DISTRICT 2 BRANCH
 LIBRARY
 U.S. HWY 87, SAN ANTONIO,
 TEXAS 78222
 Developed for
 CITY OF SAN ANTONIO

Revision	Date
1 ADDENDUM 1	11-7-14

Addendum #1 Landscape & Irrigation Narrative

PLANTING PLAN: TREE PLANTING AND LANDSCAPE ORDINANCE COMPLIANCE
SCALE - 1"=20'

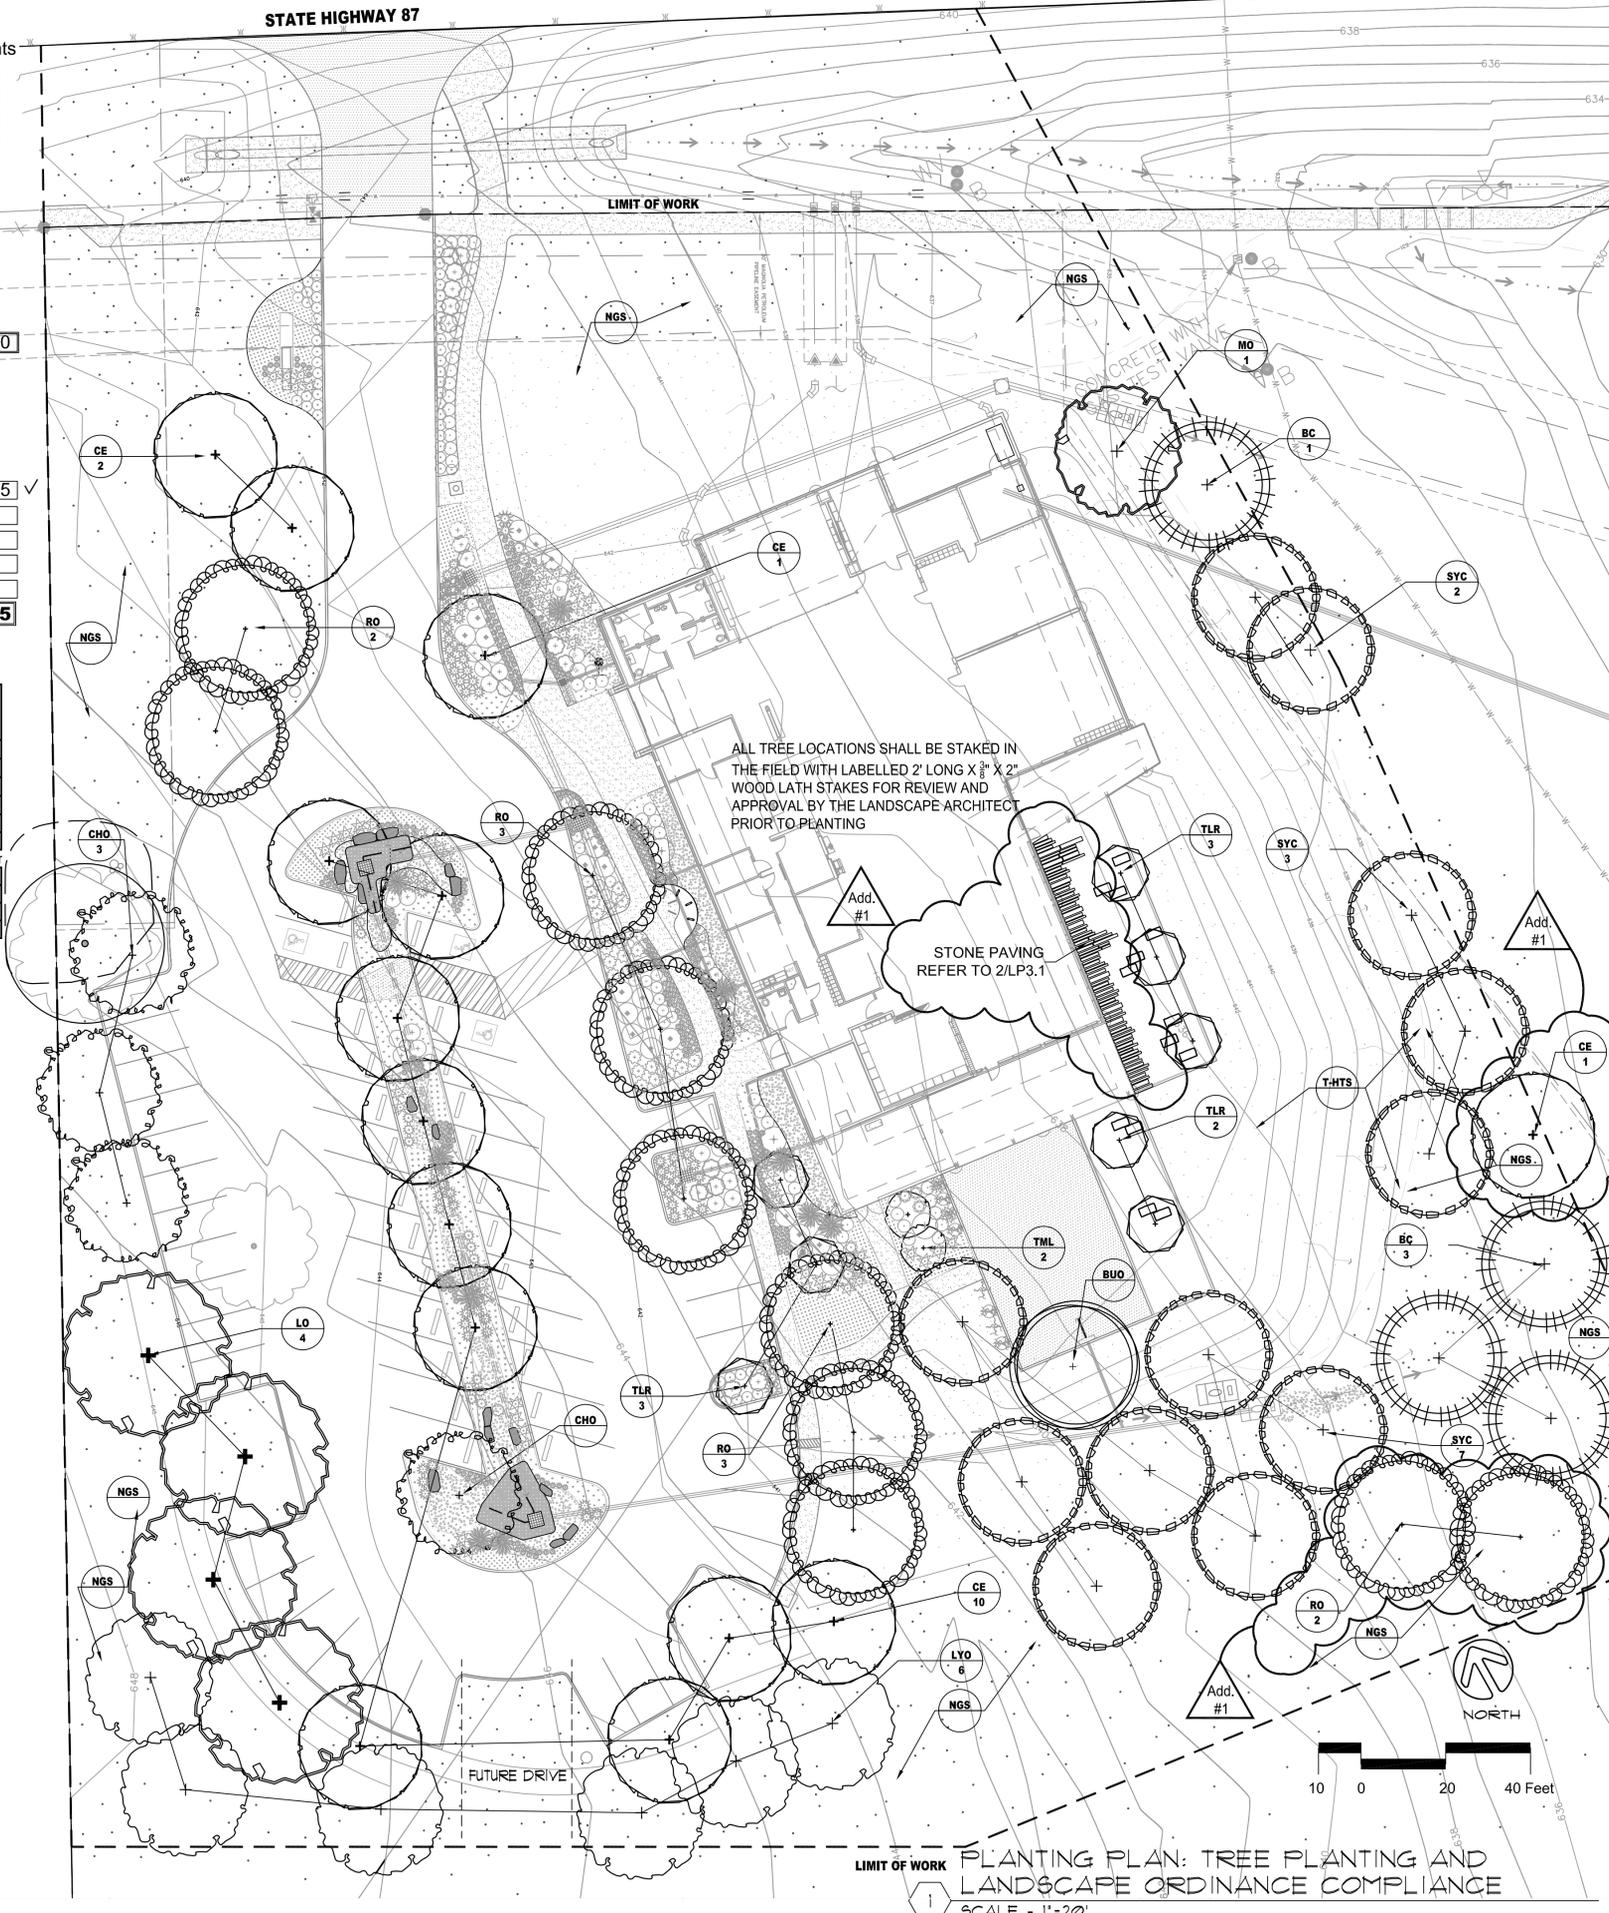
- TP1.0 Proposed Trees located to the North of the building (1 Cedar Elm & 2 Red Oaks) have been relocated to the South and Southeast of the building.
- LP1.0 Proposed Trees located to the North of the building (1 Cedar Elm & 2 Red Oaks) have been relocated to the South and Southeast of the building. Pavers spacing has been increased and now extend to the Adult Porch. The number of pavers has not changed, only the spacing.

2 DETAIL: STONE PAVING WITH GRAVEL JOINT
SCALE - 1/2"=1'

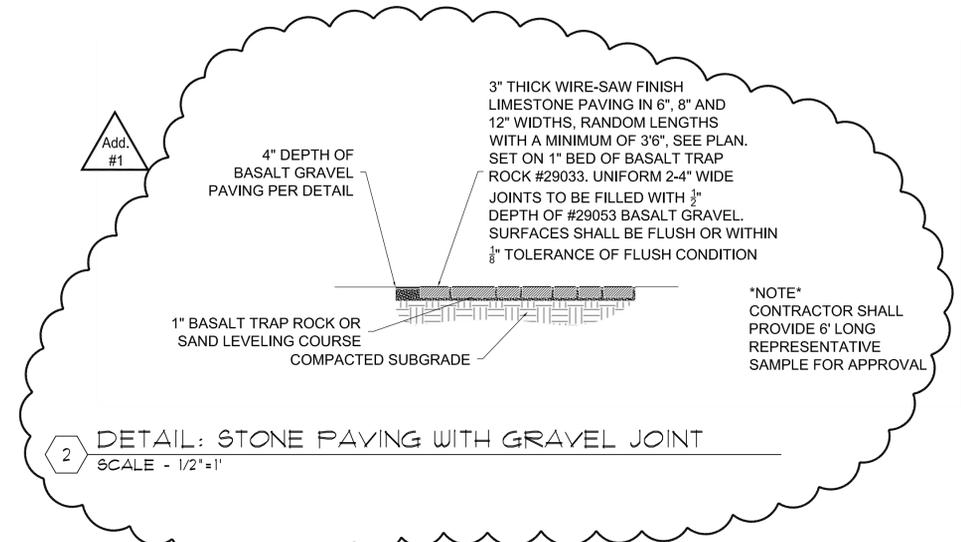
- LP1.2 Pavers spacing has been increased and now extend to the Adult Porch. The number of pavers has not changed, only the spacing.
- LP3.1 Pavers spacing was 1” and has been increased to 2” with random intervals of 4” spacing between pavers. The number of pavers has not changed, only the spacing.
